VILLAGE REVIEW BOARD
AGENDA
BRUNSWICK STATION
16 STATION AVENUE
June 6, 2013
7:15 P.M.

1. **Case #VRB 13-012 – 15 Cumberland Street (Map U13, Lot 045) –** The Board will review and take action regarding a Certificate of Appropriateness application submitted by Berean Church Trustees to construct a new access structure as an addition to the Berean Baptist Church per local code requirements.

Berean Baptist
Church-New Exit
Brunswick, Me

DRAFT Findings of Fact
15 Cumberland St
Certificate of Appropriateness
Village Review Board
Review Date: June 6, 2013

2 A2.1 NEW ELEVATIONS
3/16" = 1'-0"

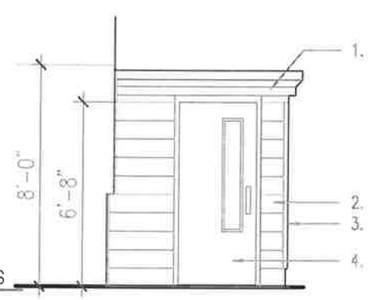
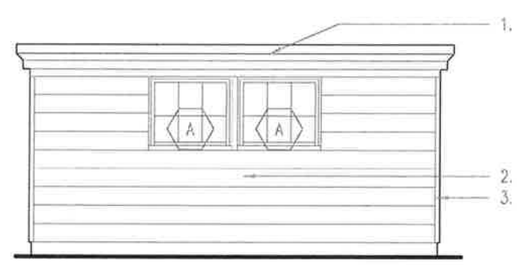
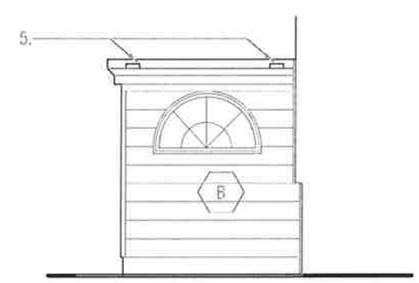
At the request of the Director of Planning & Development, the applicant revised the original architectural renderings for the addition to include use of a fascia that matches the church's existing fascia, and provision of a half-moon window in place of a small rectangular window on the addition's north façade (facing the street), to match existing half-moon windows on the church's east and north façades.

Lastly, the applicant is proposing to use a flat grain vinyl siding for the addition, similar in appearance to the church's existing vinyl siding.
